2. 1199 West Central Street

December 30, 2025

BETA Group, Inc. (BETA) has reviewed revised documents and plans for the project entitled ***Garelick Farms Flood Resiliency Improvements*** (the Project), located at ***1199 West Central Street*** (the Site) in Franklin, Massachusetts. This letter is provided to present BETA's findings, comments and recommendations.

FRANKLIN, MA
GARELICK FARMS
FLOODING RESILIENCY IMPROVEMENTS
PERMIT DRAWINGS
SEPTEMBER 2025
REVISED OCTOBER 2025
REVISED DECEMBER 2025
REVISED JANUARY 2026

**EXISTING CONDITIONS AND
SITE PREPARATION PLAN**

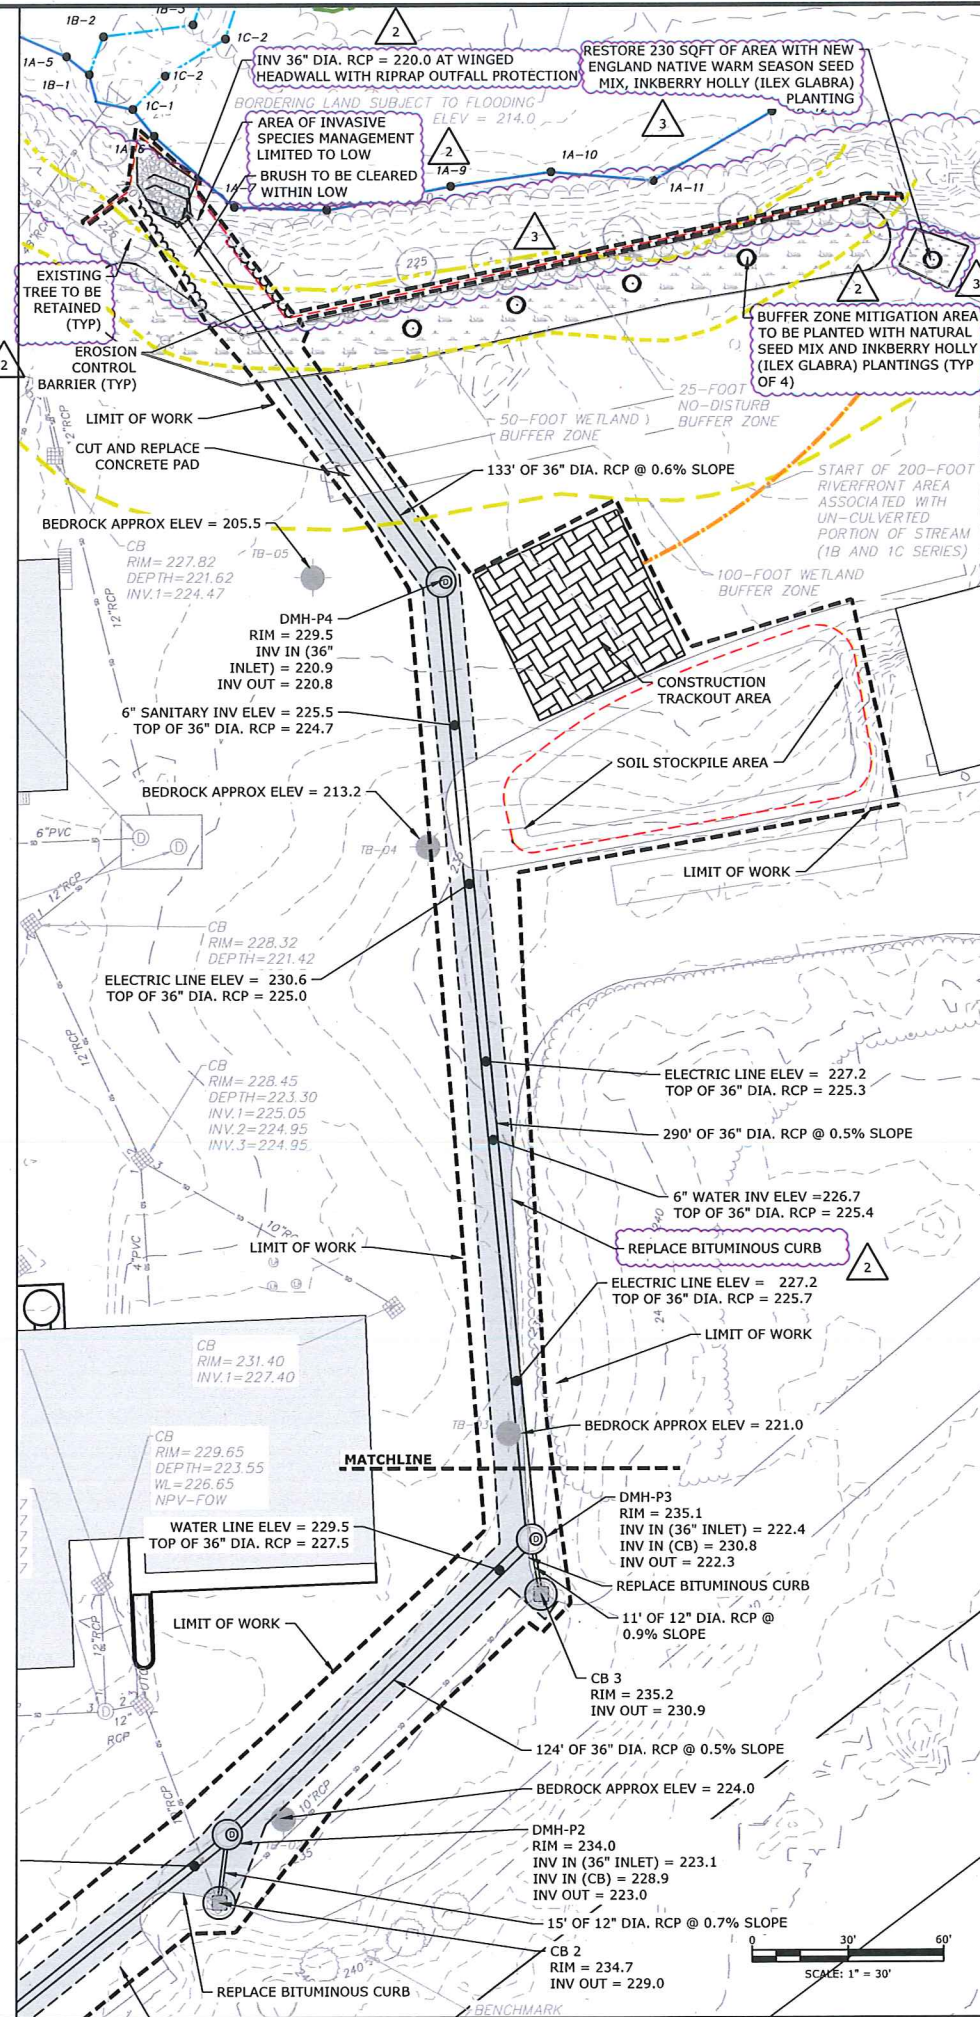
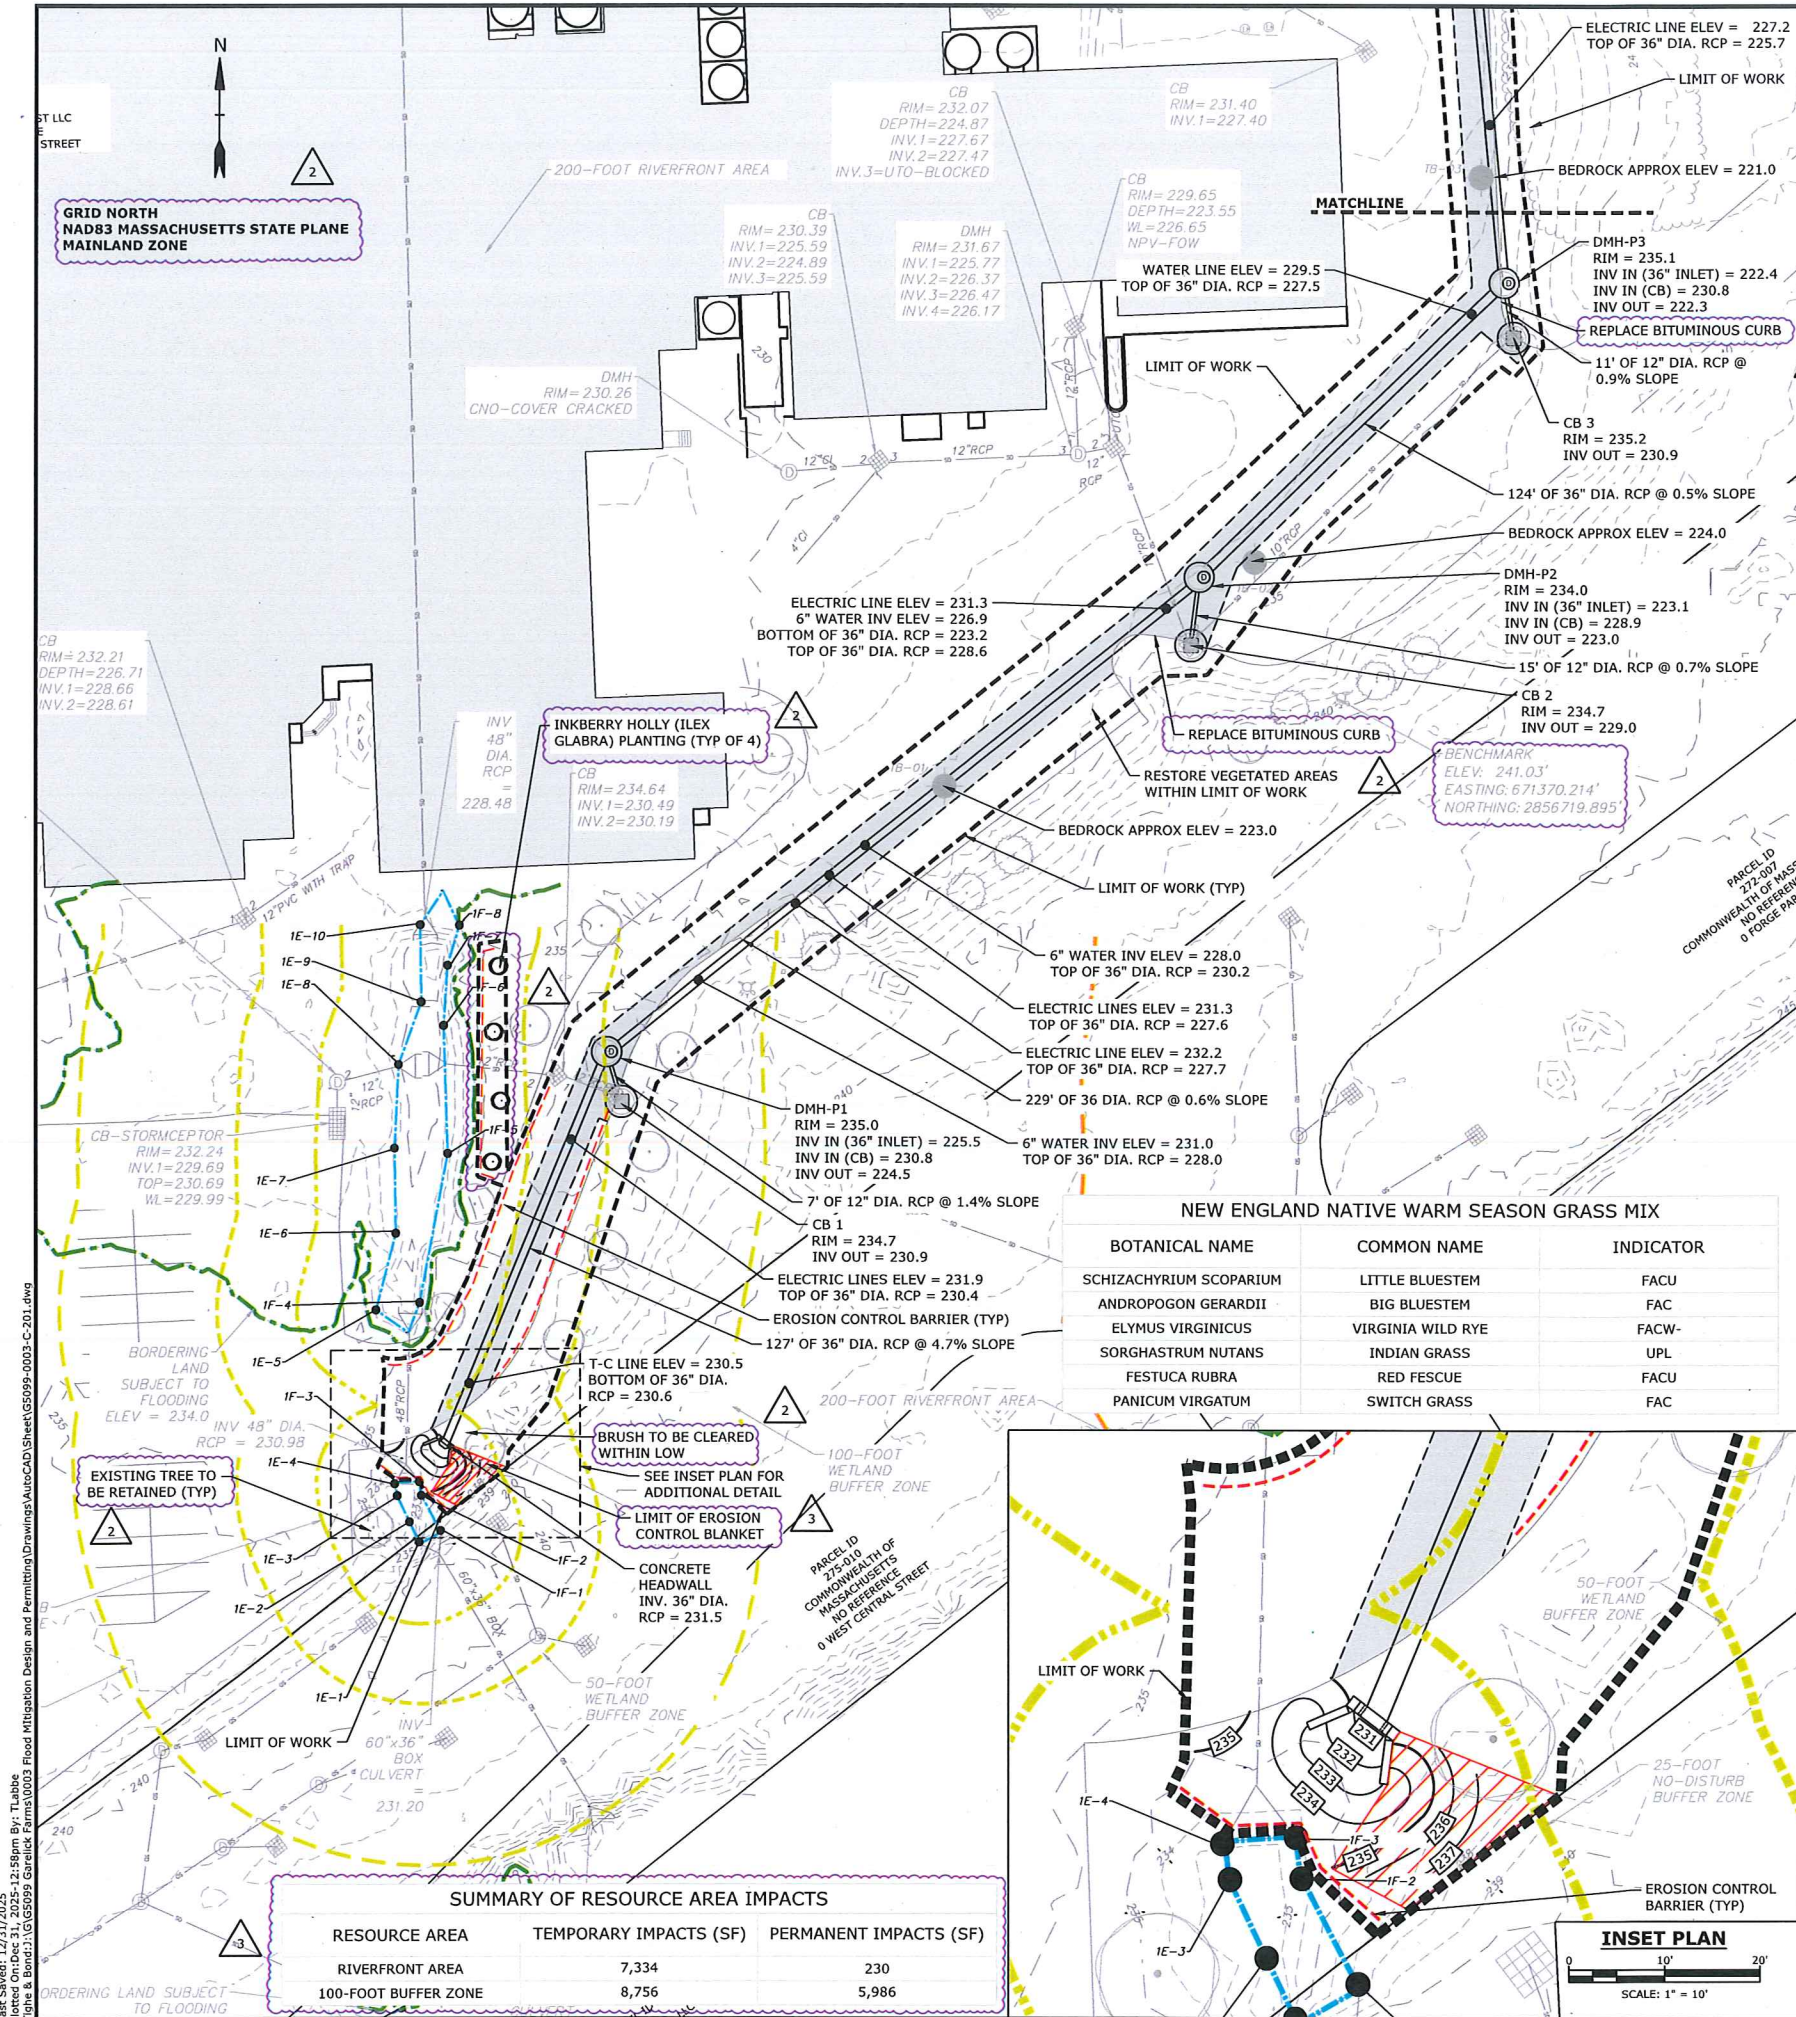
- b. Existing and proposed vegetation referenced in Bylaw Regulation Section 7.18.1.5 and 7.18.1.6 should be included on the plans, including individual trees/shrubs with a diameter greater than 1" proposed for removal. It is BETA's understanding that the Commission generally increases the size threshold for tree location based on the Project and therefore defers to the Commission on this matter. The existing and proposed tree line should be shown, and the proposed trees located along the limits of trenching should be qualified as being either removed or retained.

BETA2: Comment remains. The existing/proposed conditions tree lines are not depicted along the northern portion of the Site adjacent to the 1A Wetland Series where trees are present. The existing conditions plan appears to show a tree line in this area, but it does not encompass the locations of the individual trees that are depicted. The site plans depict a tree line in this area with a proposed conditions line weight, but it does not appear to correlate with the proposed clearing for the headwall. The tree lines should be revised as appropriate.

- W5. The limit of existing pavement and vegetated shoulder should be labeled on the plans adjacent to the location where work is proposed.

TB: Labels have been added to the Site Plans for the limits of existing pavement and vegetative shoulders. See sheet C-102.

T&B2: The existing/proposed tree lines have been added to the project plans in the area of the proposed drainage pipe and outfall installation. A note has been added on sheet C-102 to indicate that brush will be cleared within the limit of work in the area. The proposed condition tree line referred to in BETA's second round review comment appears to be the revision cloud used to indicate changes throughout various iterations of plan sets. To clarify the difference, revision clouds have been changed to purple.

C-501

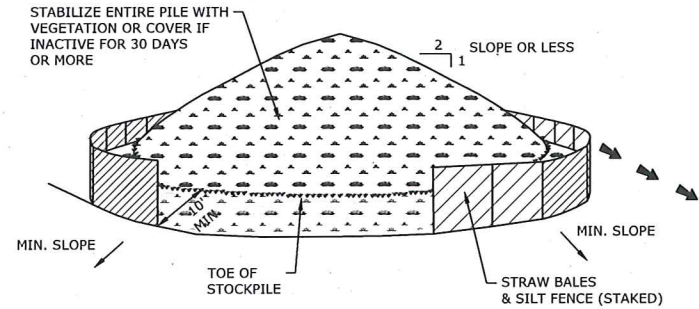
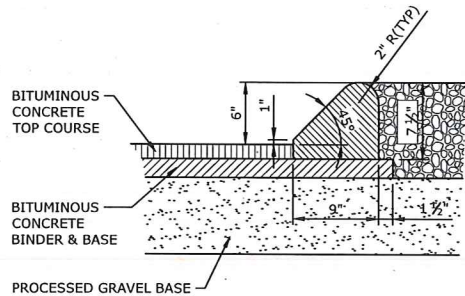
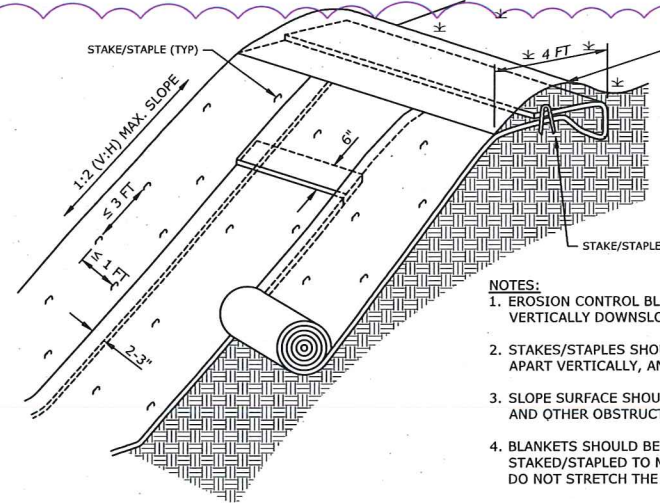
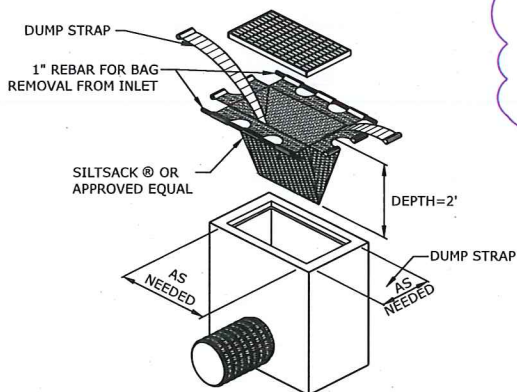
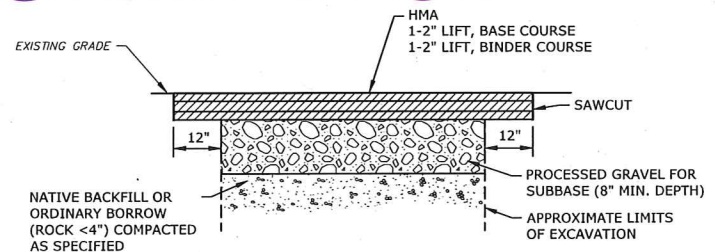
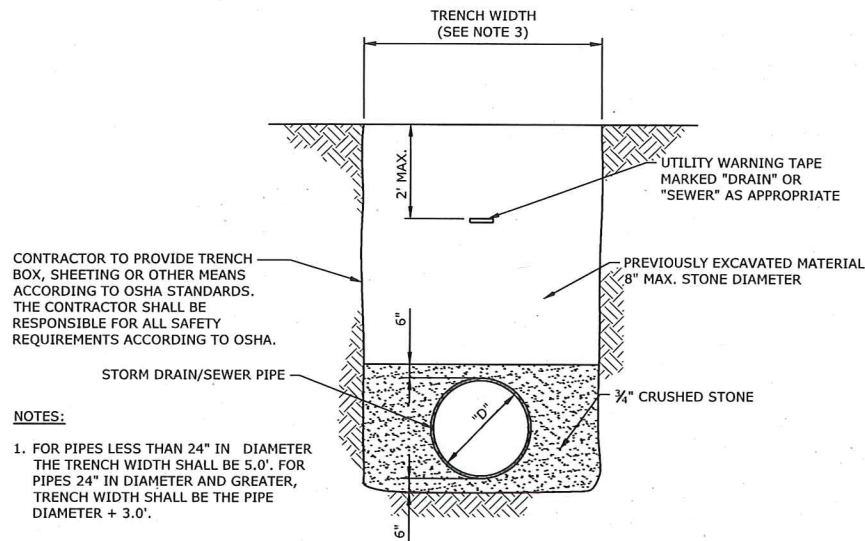
BETA2: BETA defers to the Commission on the approval of the use of straw wattles as erosion controls, as they have discouraged their use in recent years. The use of silt fence and hay/straw bales is referenced within the soil stockpile detail on page C-501 within Section 3.3 of the O&M Plan and should be revised accordingly.

- SW4. Recommend providing a detail for the replacement of curb on site.

TB: A detail for the replacement of curbing has been added to sheet C-501.

T&B2: The detail on sheet C-501 has been revised to indicate the use of compost filter tubes, and the O&M Plan has been updated to remove references to straw wattles.
